**Your Reference**  
PA/2023/421

**Our Reference**  
296328/KC

**Humber Zero: Response to Natural England Comments on VPI Humber Zero planning application**

## Appendix A – Further Information on Construction and Operational Noise

**Figure A2 – Proposed VPI Development Construction (alone) LAeq**

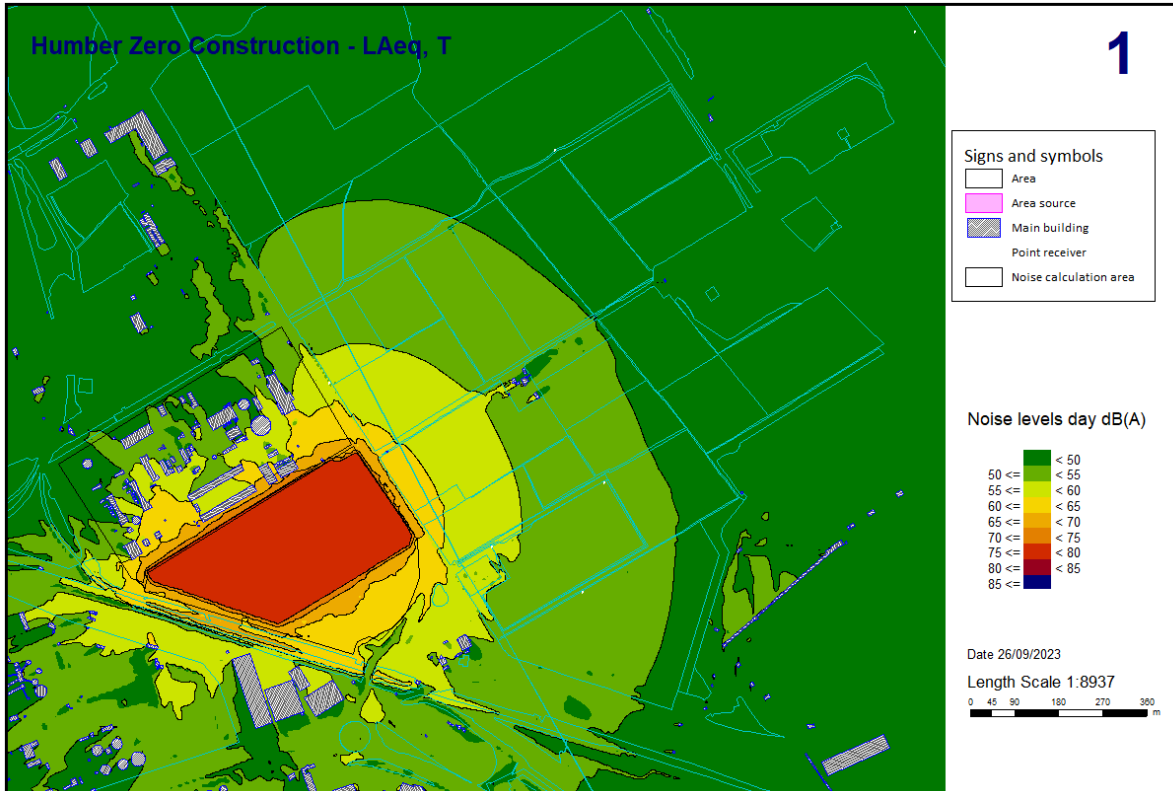
<p>Natural England advise that the baseline noise levels should be established at the locations of sensitive ecological receptors and compared to the predicted noise levels. The assessment should set the sensitive receptors in the context of the existing noise environment – i.e. how noise levels will change, including the type of noise, such as consistent or sudden loud bangs etc. Natural England note that as part of the VPI Immingham OCGT DCO the ambient range of noise levels across these fields were assessed as being 61 dB LAeq and 51 dB LAF90 along Rosper Road at the closes point of the field nearest to the proposed VPI Development, to 48 dB LAeq and 43/ 46 dB LAF90 along the easter edge.</p>	<p>Additional baseline noise monitoring has been undertaken – see <b>Appendix A</b>.</p>

Noise contours have been prepared for the construction phase to show the predicted LAeq and LAm<sub>ax</sub> at the ecology receptors. A summary of the predicted changes in LAeq and LAm<sub>ax</sub> as a result of construction are presented in Table A1 below. The modelling demonstrates that there are no predicted exceedances of the suggested 3 dBA 'rule-of-thumb' change in noise level threshold at the ecology receptors. At Eco 1 there is a predicted change of + 3 dBA; however, both the ambient noise levels and construction noise levels at this receptor are below 50 dB LAeq, which is equivalent to the sound of moderate rainfall and below even noise levels arising from normal conversation (60 dBA). It is therefore reasonable to conclude that the effects of construction noise at this location would not result in likely significant effects on SPA/ Ramsar waterbirds using functionally linked land.

Receptor Location	LAeq (Figure A2)			LAm <sub>ax</sub> (Figure A3)		
	Ambient	Construction	Increase above ambient	Ambient	Construction	Increase above ambient
<b>Daytime</b>						
Eco 1	44	47	+3	60	20	No change
Eco 2	73	53	No change	93	29	No change
Eco 3	51	52	+1	69	28	No change
Eco 4	53	52	No change	70	28	No change
<b>Nighttime</b>						
Eco 1	48	47	No change	46	20	No change
Eco 2	64	53	No change	59	29	No change
Eco 3	50	52	+2	49	28	No change
Eco 4	52	52	No change	50	28	No change

**Figure A4 – Proposed VPI Development Operation (alone) LAeq**

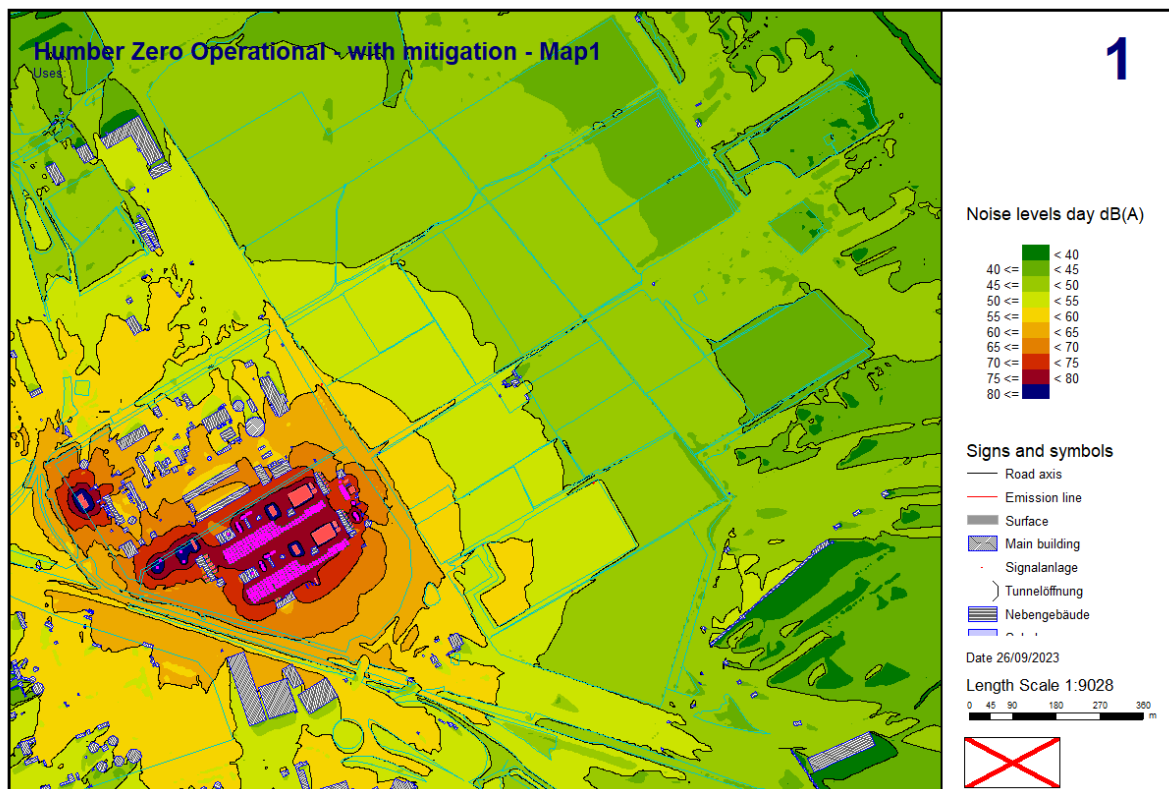
Natural England Comment	Applicant's Response
<p>Natural England is unclear if the noise modelling has been undertaken in an ecological context and if mitigation is required to mitigate adverse effects on integrity to the Humber Estuary qualifying species.</p>	<p>Additional baseline noise monitoring has been undertaken – see <b>Appendix A</b>.</p> <p>The mitigation referred to that has been incorporated into the noise modelling is referring to mitigation required for human receptors. There is no requirement for ecological noise mitigation, as no significant effects on ecology receptors as a result of construction or operational noise have been identified.</p>
<p>Natural England will assess the in-combination assessment once the HRA has been updated with further detail on how the predicted noise levels will change compared to the ambient noise levels.</p>	<p>Comparisons of the predicted changes in noise levels for the construction and operation of the Proposed VPI Development in combination with construction and operation of the Proposed Phillips 66 Development, Land at Westgate and Viking CCS are presented in <b>Appendix A</b>.</p> <p>The additional modelling undertaken has provided further evidence to underpin the conclusions previously presented in respect of in-combination construction and operational noise impacts.</p> <p>N.B. In-combination noise contour plans for the 'Proposed VPI Construction In Combination with Operation of Proposed Phillips 66 Development and Land off Westgate, Immingham Construction and Viking CCS'; and 'Proposed VPI Operation In Combination with Operation of Proposed Phillips 66 Development and Land off Westgate, Immingham Construction and Viking CCS' have not been prepared – this is due to the complexities in combining the output of three models, which would result in an unrealistic implied level of accuracy. Therefore, predicted in-combination noise levels for all four developments are provided at the four receptor locations only.</p>

A noise contour has been prepared for the operational phase to show the predicted LAeq at the ecology receptors. A summary of the predicted changes in LAeq as a result of operation are presented in Table A2 below. The modelling demonstrates that there are no predicted exceedances of the suggested 3 dBA 'rule-of-thumb' threshold at the ecology receptors. A 'with mitigation' scenario has been modelled for the operational phase as this includes noise mitigation measures required for environmental compliance and is not related to ecological mitigation (as no ecological mitigation is required).

Receptor Location	LAeq (Figure A4)		
	Ambient	Operation	Increase above ambient
<b>Daytime</b>			
Eco 1	44	46	+2
Eco 2	73	55	No change
Eco 3	51	50	No change
Eco 4	53	50	No change
<b>Nighttime</b>			
Eco 1	48	46	No change
Eco 2	64	55	No change
Eco 3	50	50	No change
Eco 4	52	50	No change
